RE: Netgear Incorporated, FCC ID: PY3-ANT24BX

Our responses to your comments on the above referenced application, are embedded with the issues that you raised.

Plot2 (Channel 11) ☐

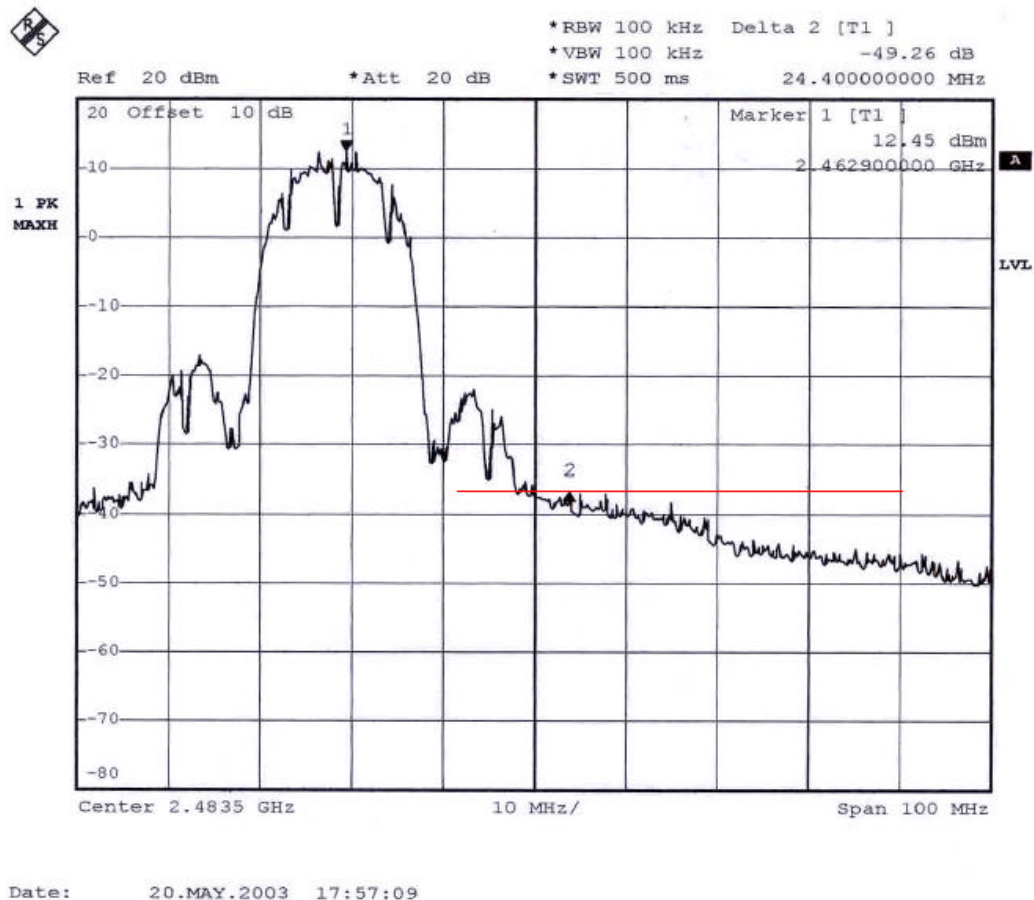
11) The band edge measurement above 2.4835 GHz appears that the marker 2 may not have been on the highest measurements above 2.4835 GHz band edge. Given how close the results were (0.2 dB from the limit), please verify that the marker was correctly positioned on the highest point above 2.4835 GHz.

The marker 2 is on the correct point on the graph. The tip of the marker's triangle and not the center/base of the triangle indicates the trace value. The tip is above all other out-of-band signals
